Staff Report

To: Salt Lake City Planning Commission
From: Aaron Barlow, Principal Planner – 385-386-2764 – aaron.barlow@slcgov.com
Date: April 22, 2021
Re: Ville 9 Apartments - PLNPCM2020-00923 & PLNPCM2021-00098 – Design Review & Planned Development

Design Review & Planned Development

JOE COLOSIMO PROJECT
1025 NORTH 900 WEST
SALT LAKE CITY, UTAH 84116
CONCEPT LANDSCAPE PLAN

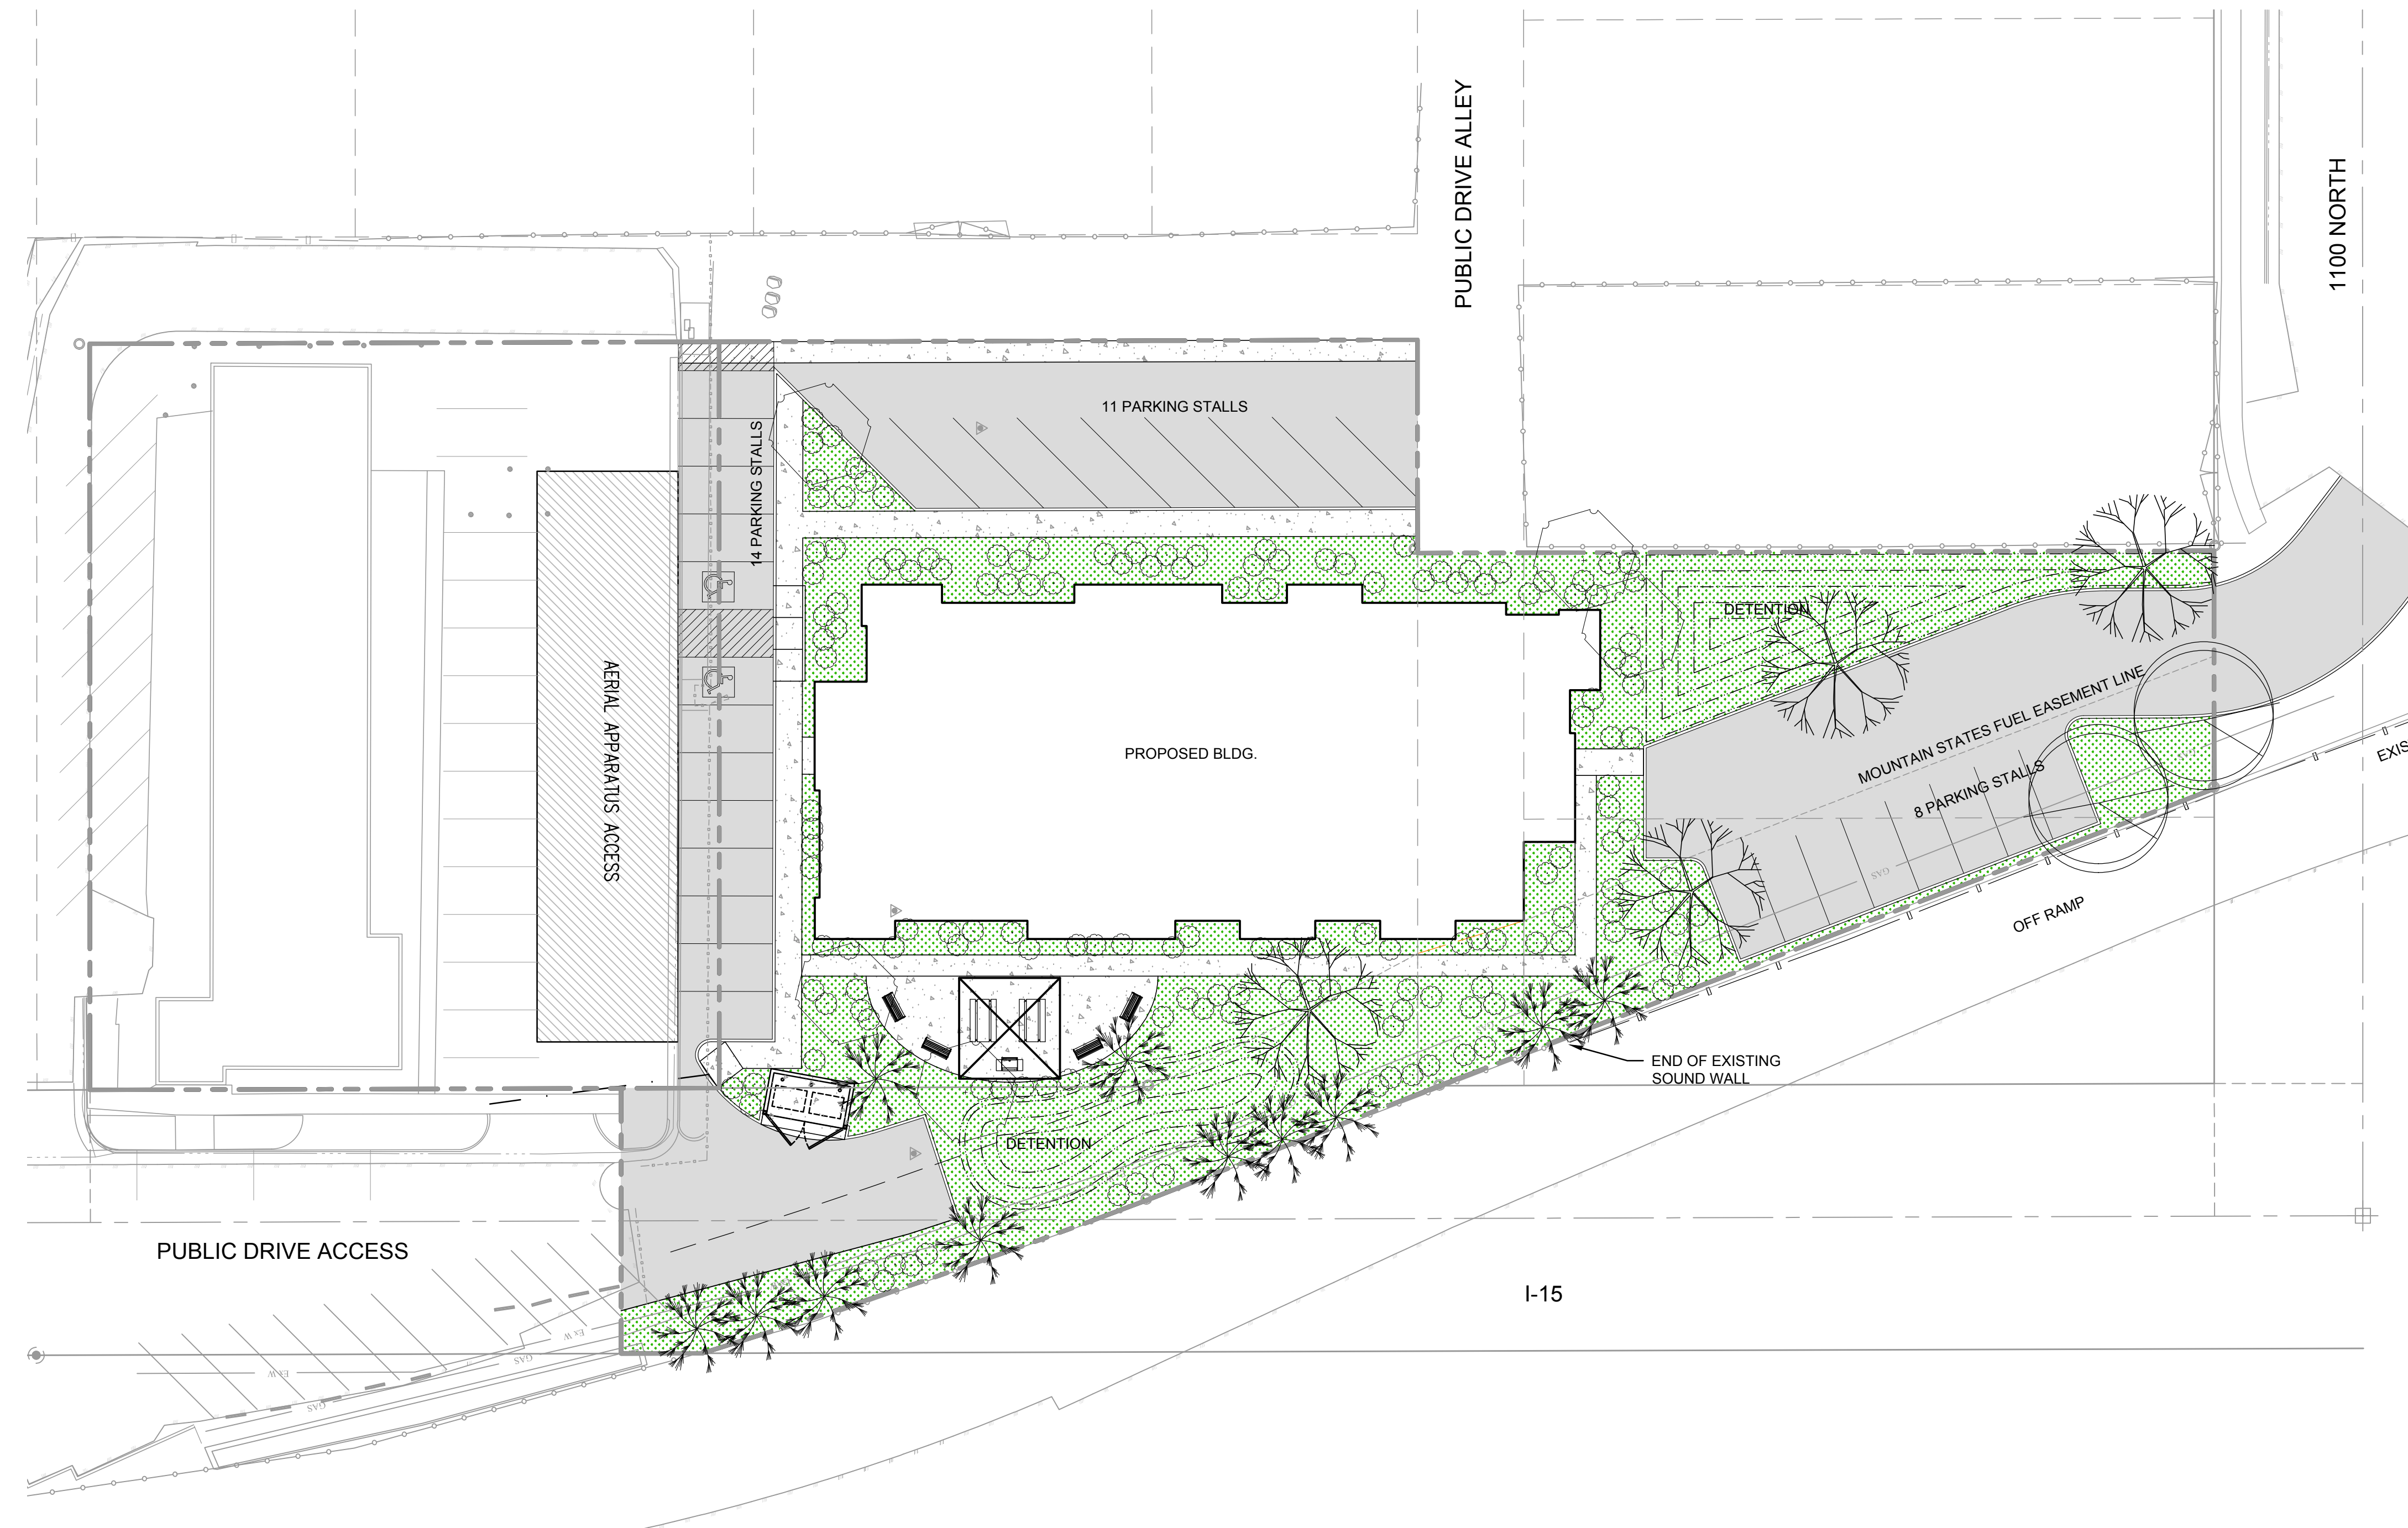
1. Whether mature native trees located along the periphery of the property and along the street are preserved and maintained;		Based on the landscaping plans provided by the applicant, it appears that some of the more significant trees on the lot will be preserved.

2. Whether existing landscaping that provides additional buffering to the abutting properties is maintained and preserved;		The property only abuts one single-family house (that is within the RMF-35 district). The plans propose new trees that will screen the proposed building from the single-family residence.

3. Whether proposed landscaping is designed to lessen potential impacts created by the proposed planned development; and;		The applicant has proposed new trees near the northwest corner of the proposed building. This appears to be an attempt to soften the impact of the building on the abutting single-family residential lot.
